November 22, 2002

RE: Stanton Energy Center Combined Cycle Unit A File No. PSD-FL-313 (PA81-14SA2) Request for Revision of Condition Number 41

Figure 2 – Emissions Performance Curves for GE DLN-2.6 Combustor Firing Natural Gas in a Dual Fuel GE 7FA Combustion Turbine

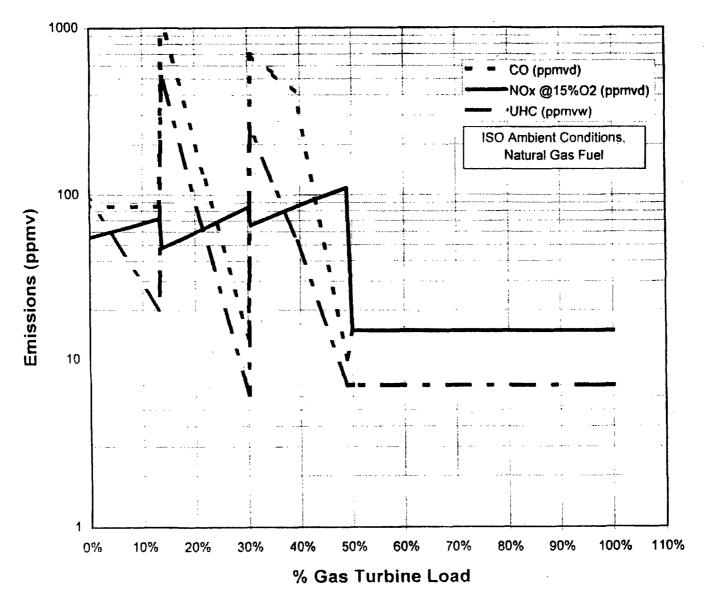
For instance, the NOx value (gas fired) on the attached figure illustrates a NOx value as high as approximately 105 ppmvd. This is well above the upper range specified in the permit (30 ppm). According to Part 75, Appendix A 2.1.2.3, "The high span value of the NOx value shall be determined by multiplying the MPC [maximum potential concentration] (~105 ppmvd) by a factor of no less than 1.00 and no greater than 1.25." This would result in an upper span value of approximately 140 ppm. When emissions during oil firing are considered, the maximum potential concentration for NOx can be 200 ppm. (Note: The utilization of oil would likely present short-term values above the curves provided in the attached figure.)

In regard to CO, the permit specifies a span value for the lower range of 20 ppm and an upper range of no greater than 100 ppm. As illustrated in the attached figure, CO values can have an instantaneous high of almost 950 ppm. As stated above, when fuel oil is utilized, the maximum value could be higher, with a correspondingly higher span value.

Because the upper span values specified in the permit for both the NOx and CO monitors are inconsistent with existing regulatory requirements under Parts 75 and 60, the permit should be revised to delete the specific values. A better approach would be to simply refer to the federal regulations.

We therefore propose the following revisions to the second paragraph of Condition 41, which will ensure the best means of obtaining the most accurate air emissions data:
